621 CS-01 Before

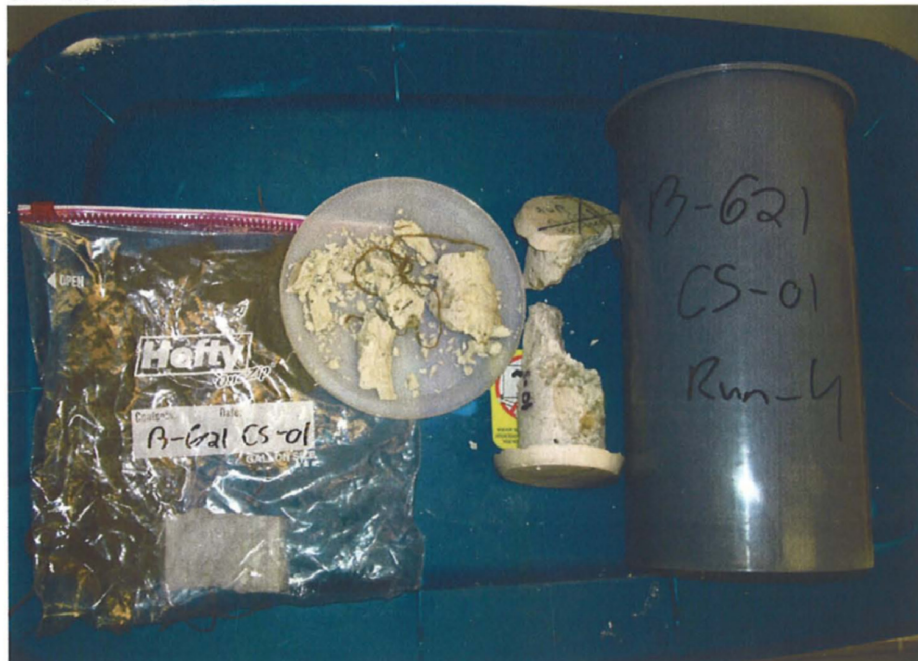
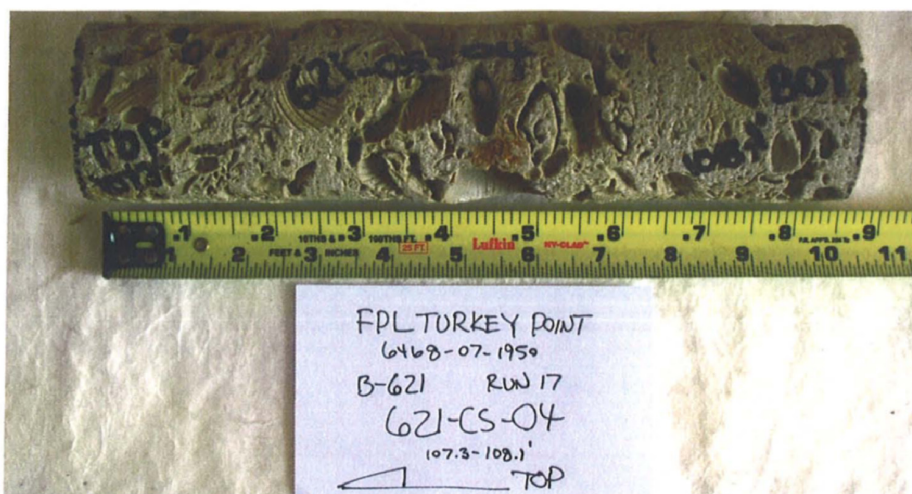
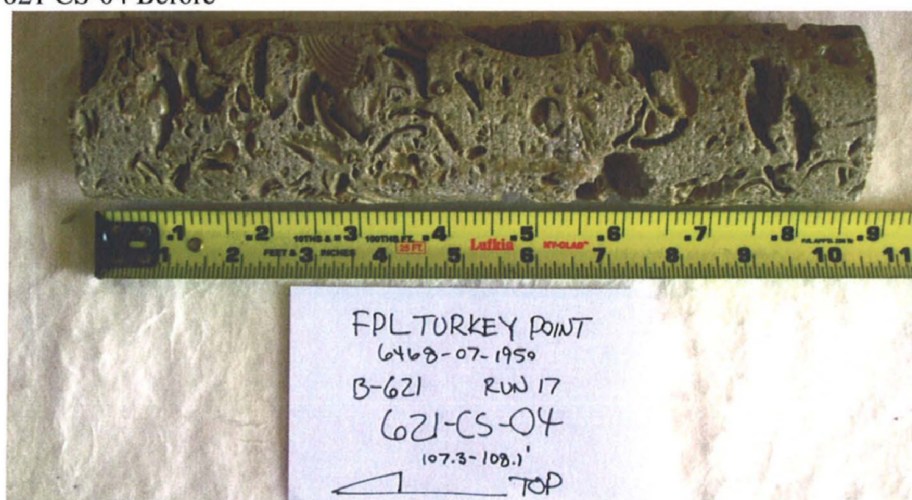
621 CS-01 Before

621 CS-01 After

621 CS-04 Before

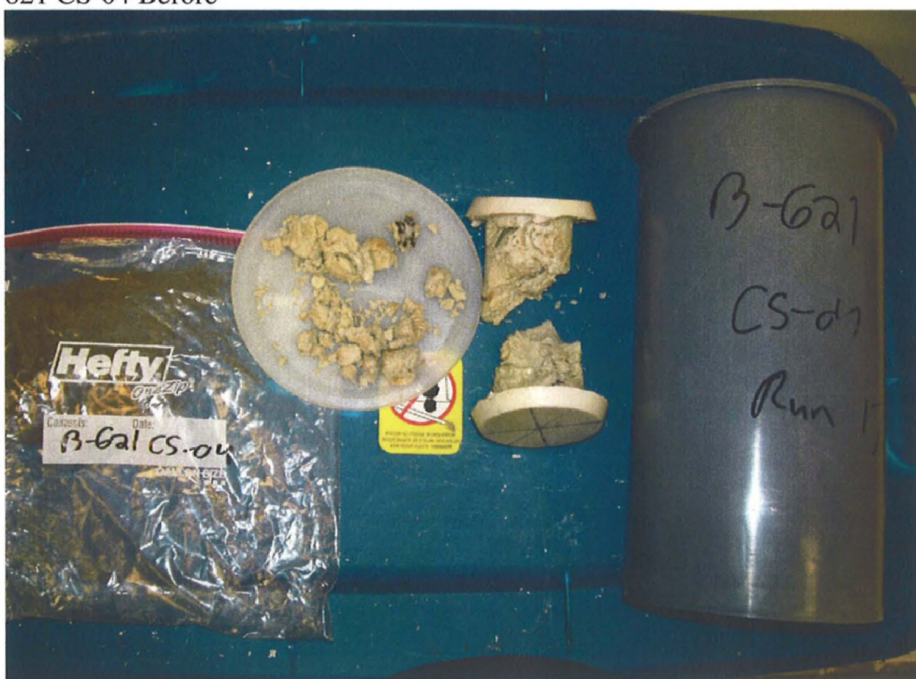
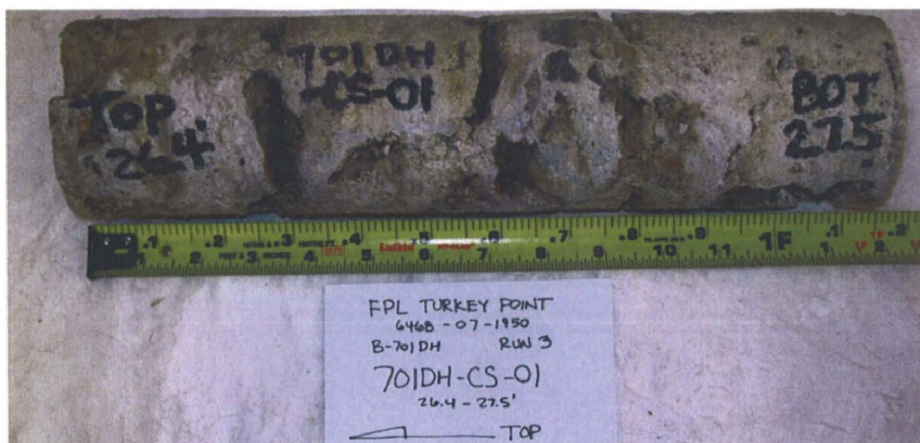
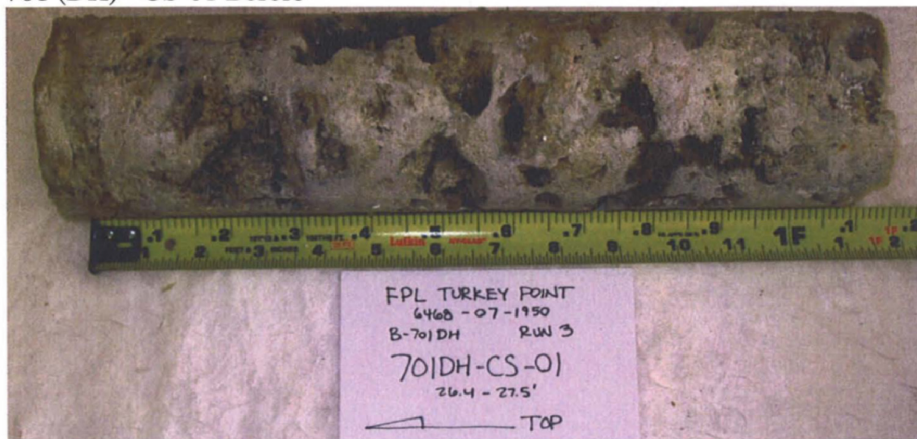
621 CS-04 Before

621 CS-04 After

701 (DH) - CS-01 Before

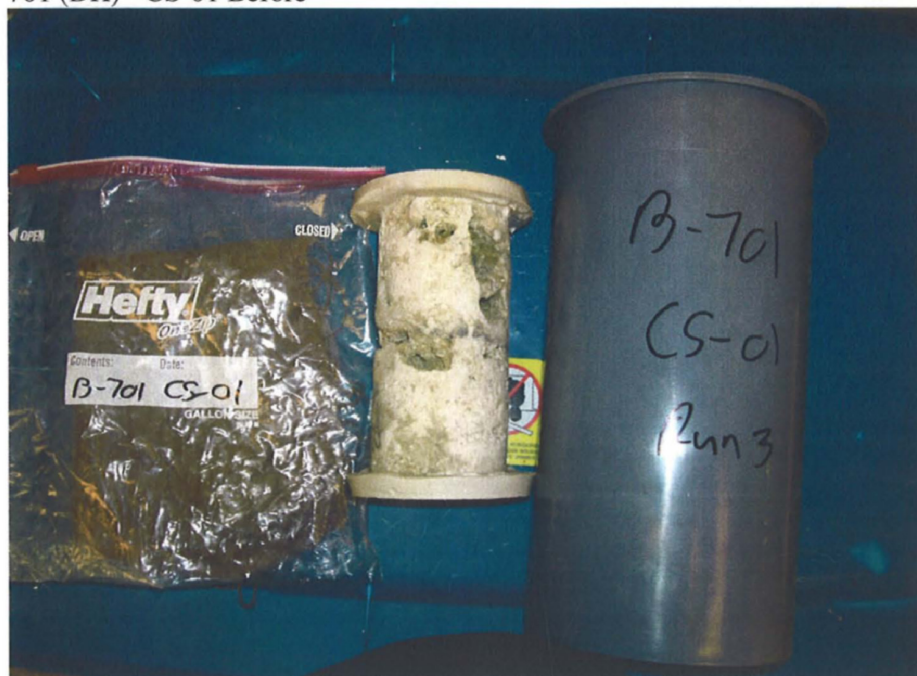
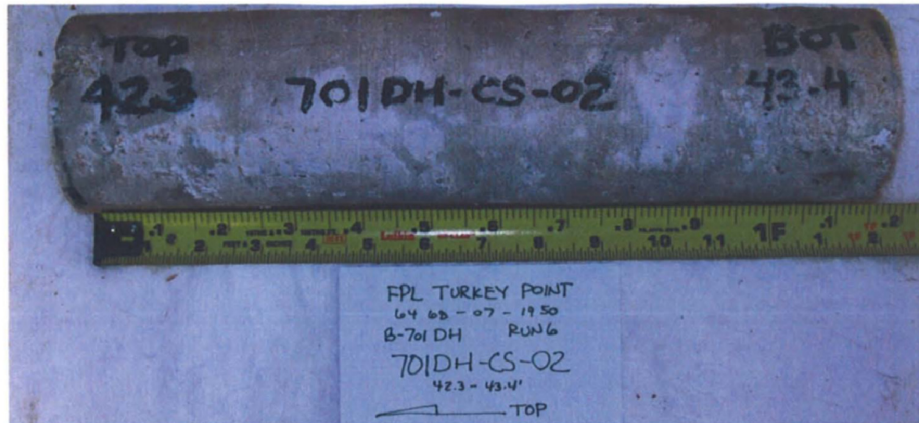
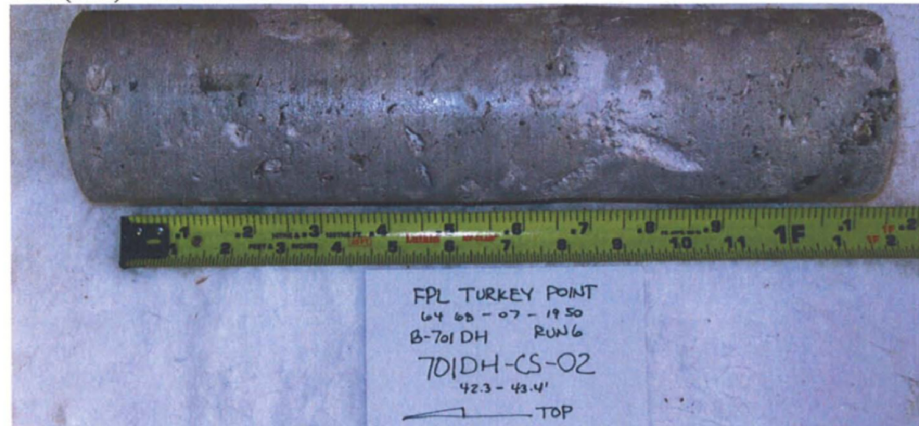
701 (DH) - CS-01 Before

701 (DH) - CS-01 After

701 (DH) - CS-02 Before

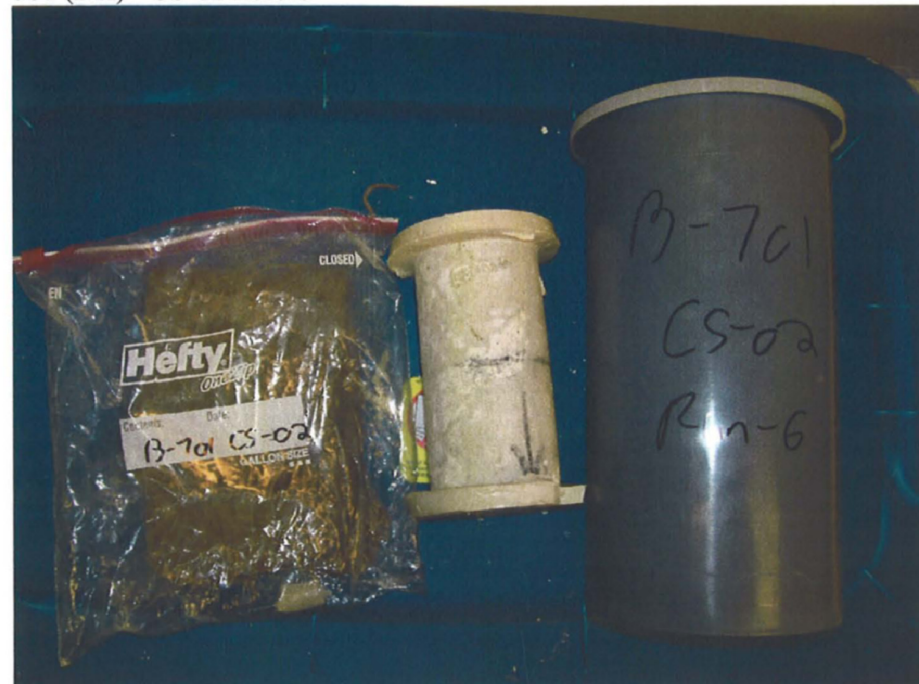
701 (DH) - CS-02 Before

701 (DH) - CS-02 After
